Exhibit A: 02/05/16: Tier 1 Project Revisions

CANDLESTICK POINT
Proposed Project Revisions Associated with Development Plan Application for Sub-Phase 02-03-03 and Updates to Project Documents, Including:
CP Major Phase 1 Application, CP Design for Development (D4D),
CP Streetscape Master Plan, CP-HPS-Phase 2 MMRP, CP Transportation Plan

CANDLESTICK POINT
Tier 2 and Tier 3 Revisions Associated with Development Plan Application for Sub-Phase 02-03-03 and Updates to Project Documents, Including:
CP Major Phase 1 Application, CP Design for Development (D4D),
CP Streetscape Master Plan, CP-HPS-Phase 2 MMRP, CP Transportation Plan

Candlestick Point Design For Development _ Figure 4.3 Building Heights

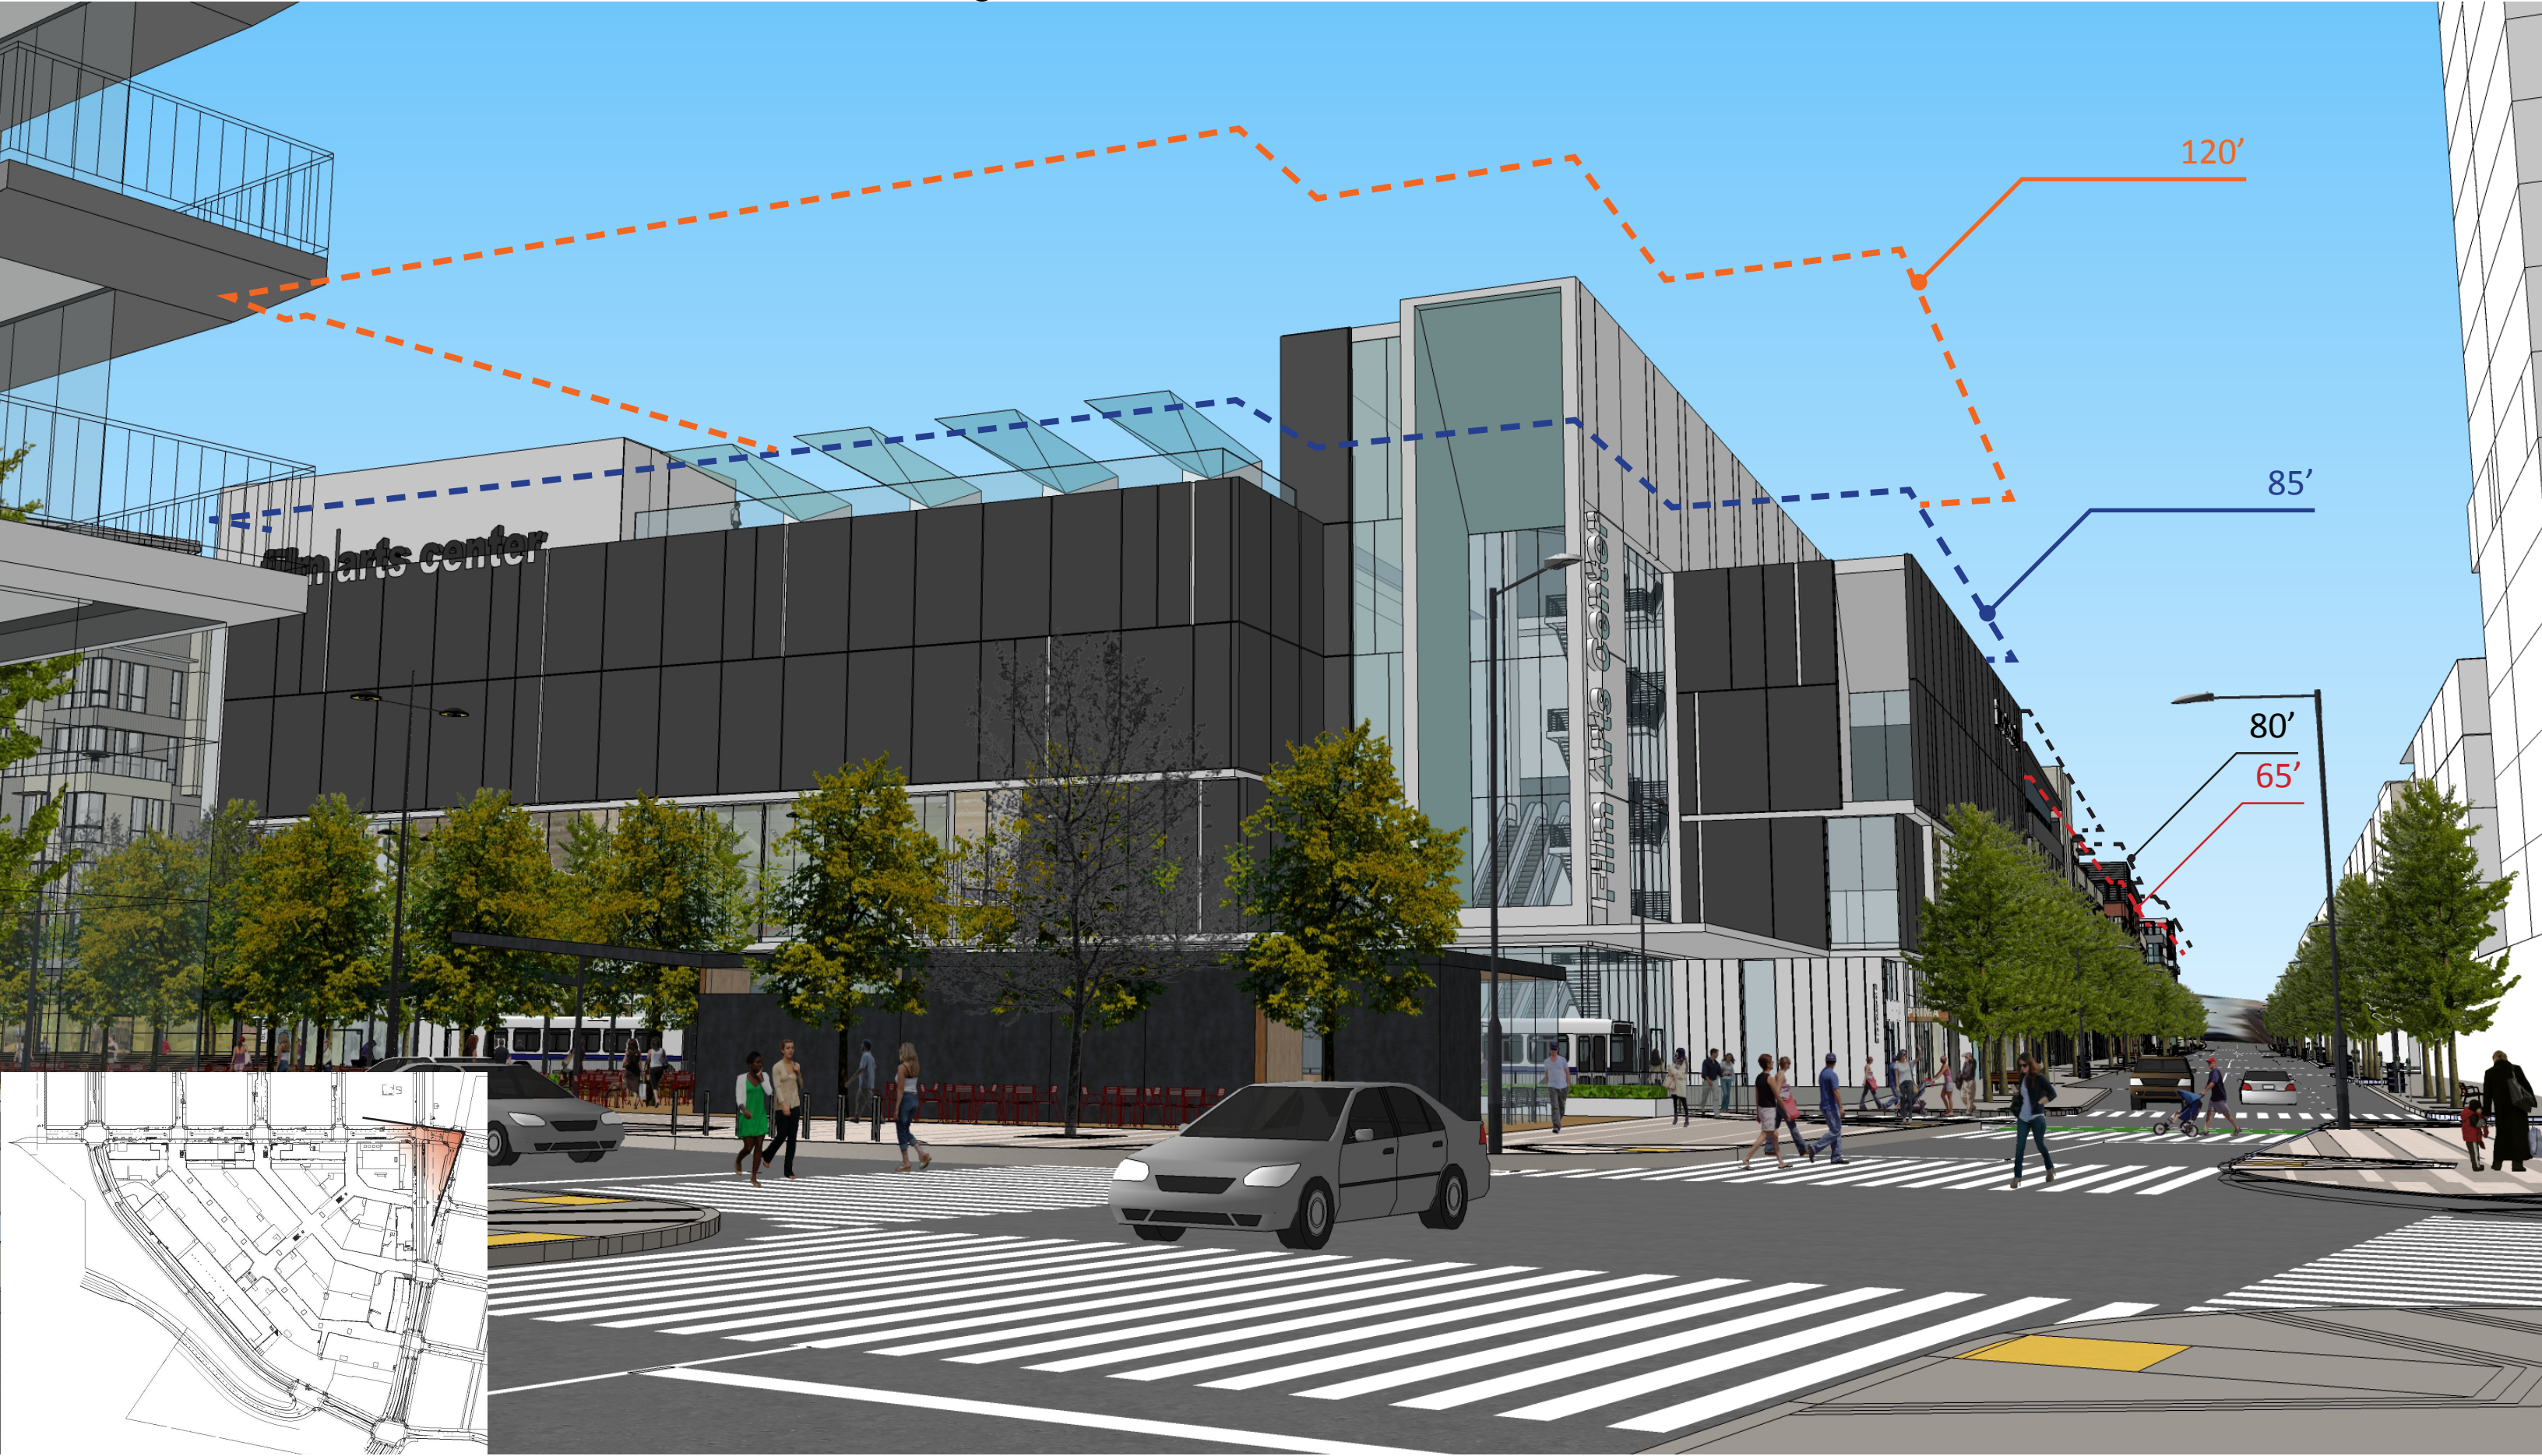
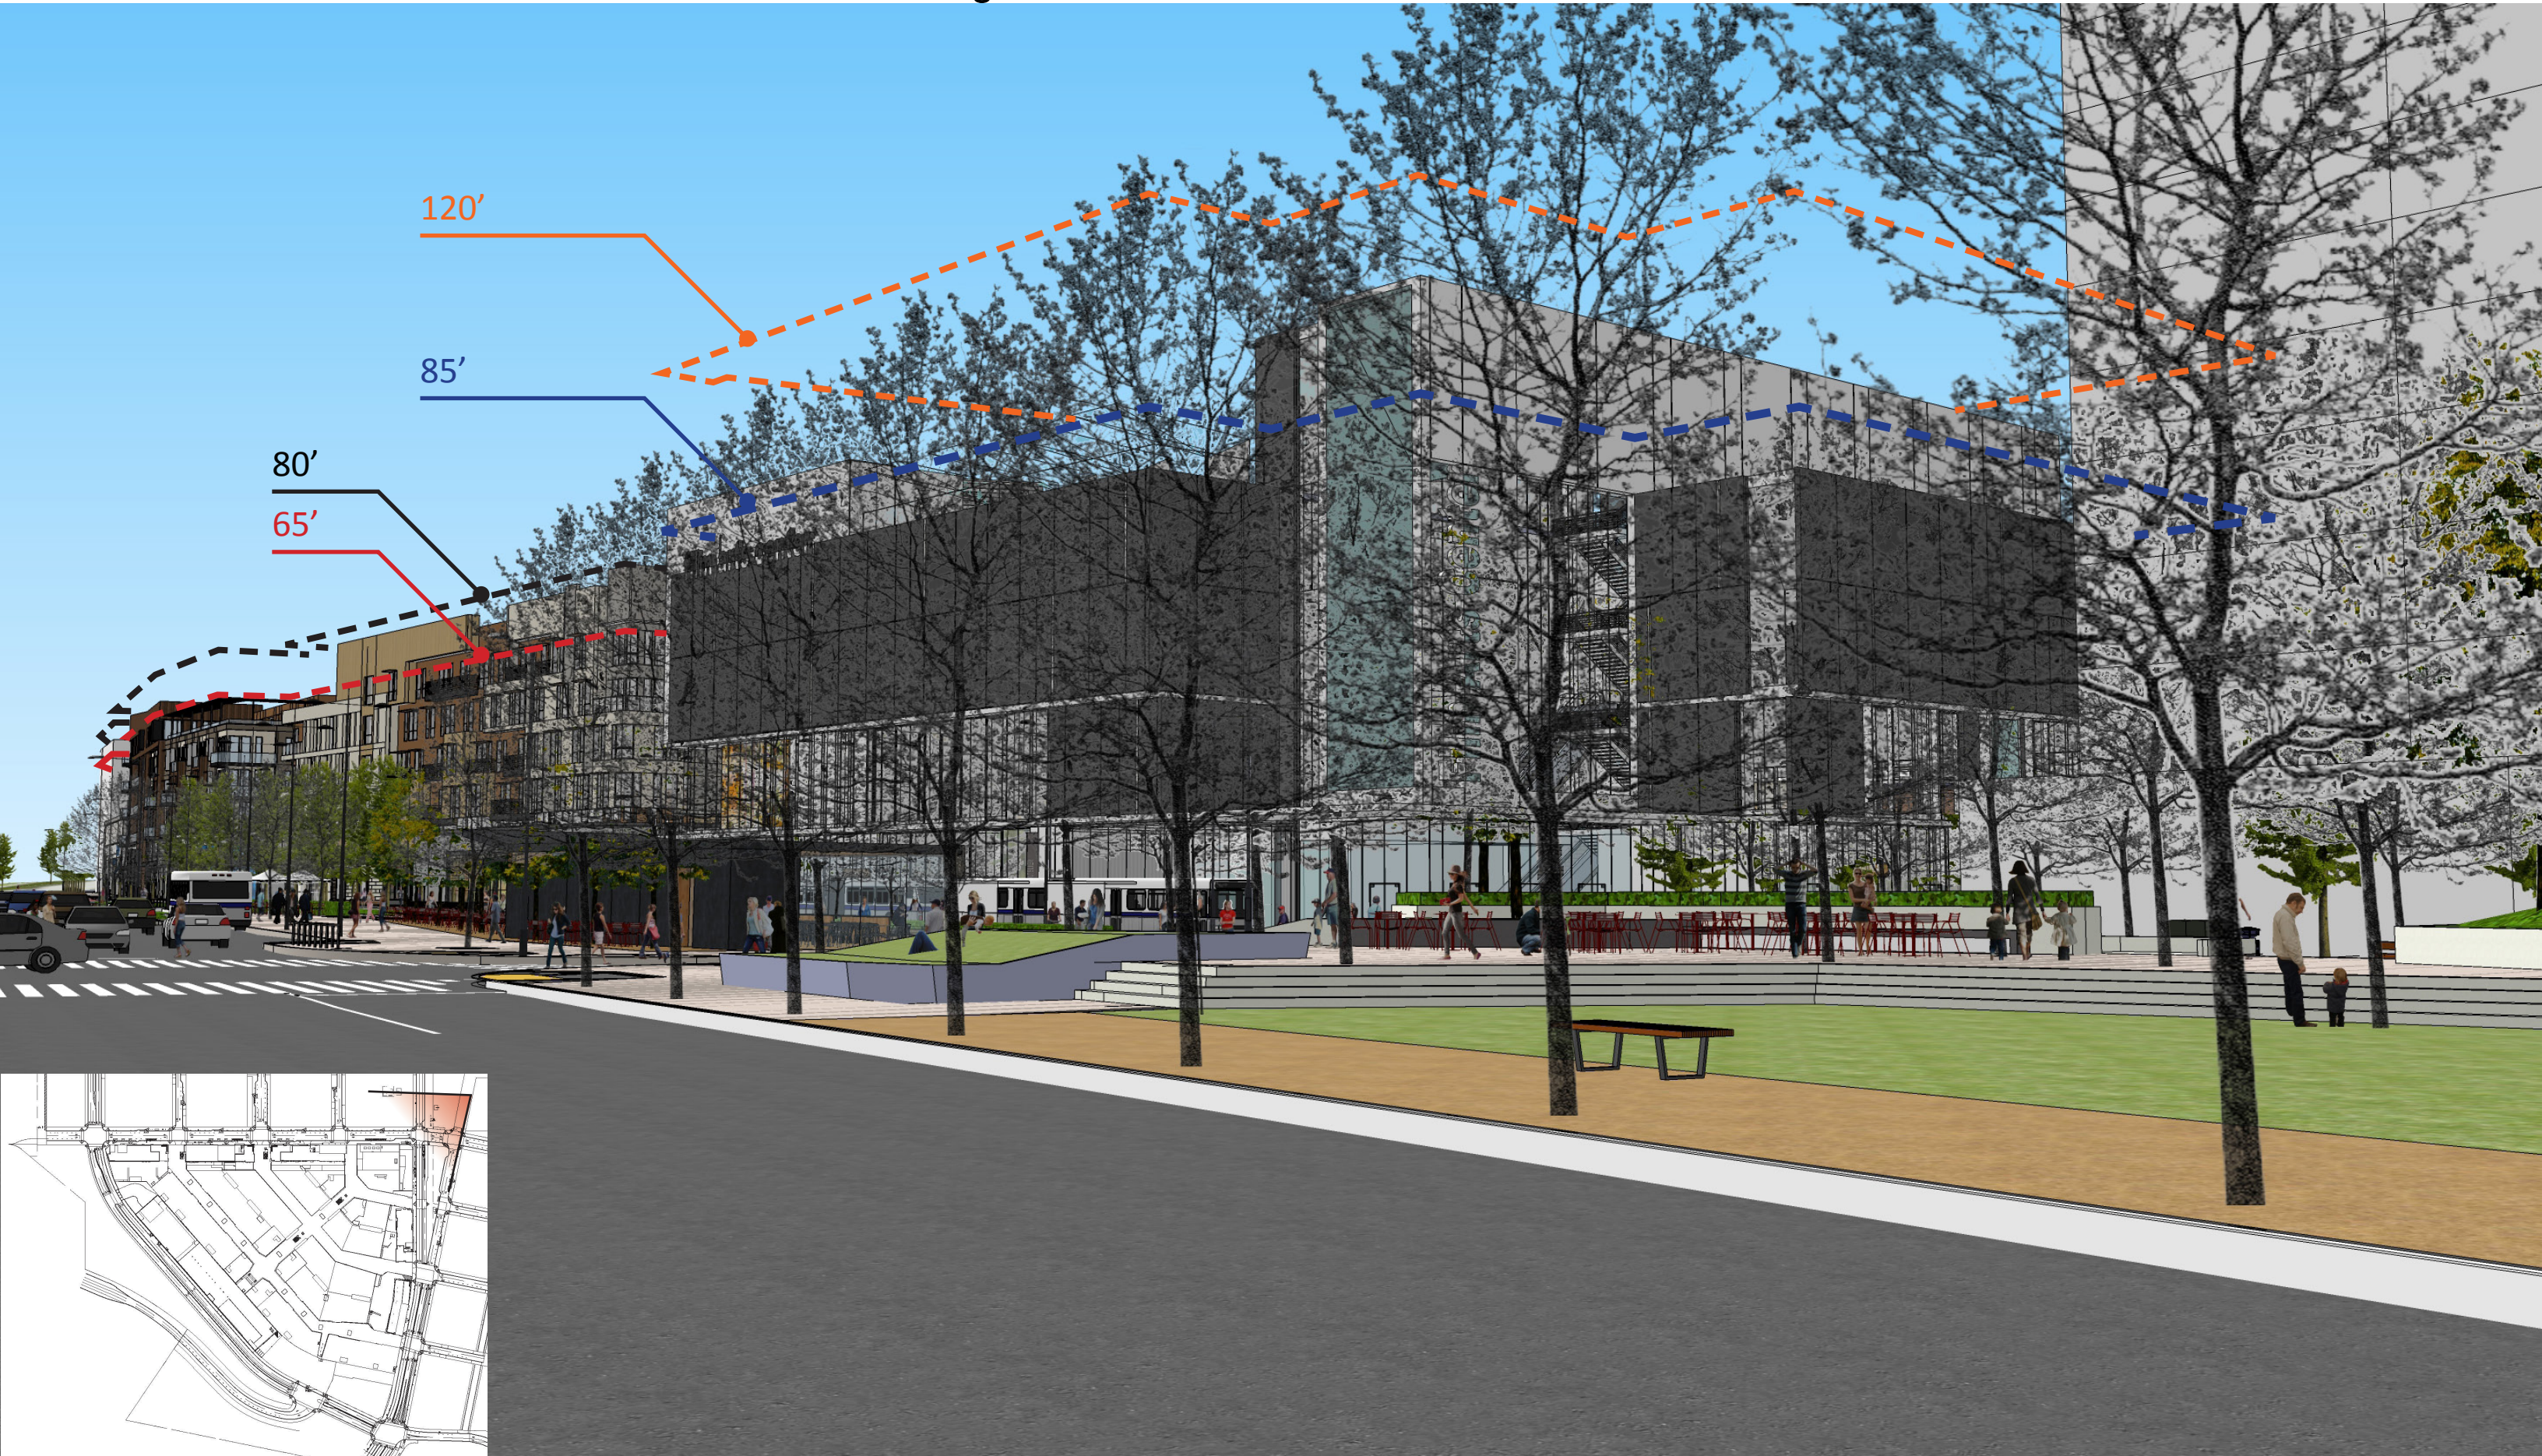
Proposed Revision	Existing Provision	Project Document(s) Revision
TIER 1: Substantive Project Revisions		
1. <u>Tower Relocation</u> : The sub-phase application proposes relocating Towers G, J and K. Tower G would be relocated within CP-02, but outside the approved tower zone. Tower J and K would be moved approximately 100 feet southeast. Tower K would remain in an approved tower zone and Tower K would be in a new fixed location.	D4D located Tower G in the approved tower location in the center of CP-02. D4D located Towers J and K in CP-South, approximately 100 feet north of the proposed location.	Major Phase 1 Application <ul style="list-style-type: none">• Section 1.1• Figure 6.1• Figure 6.5• Figure 6.6• Figure 6.7• Figure 6.8 D4D: <ul style="list-style-type: none">• Table 4.3• Figure 4.3• Figure 8.1
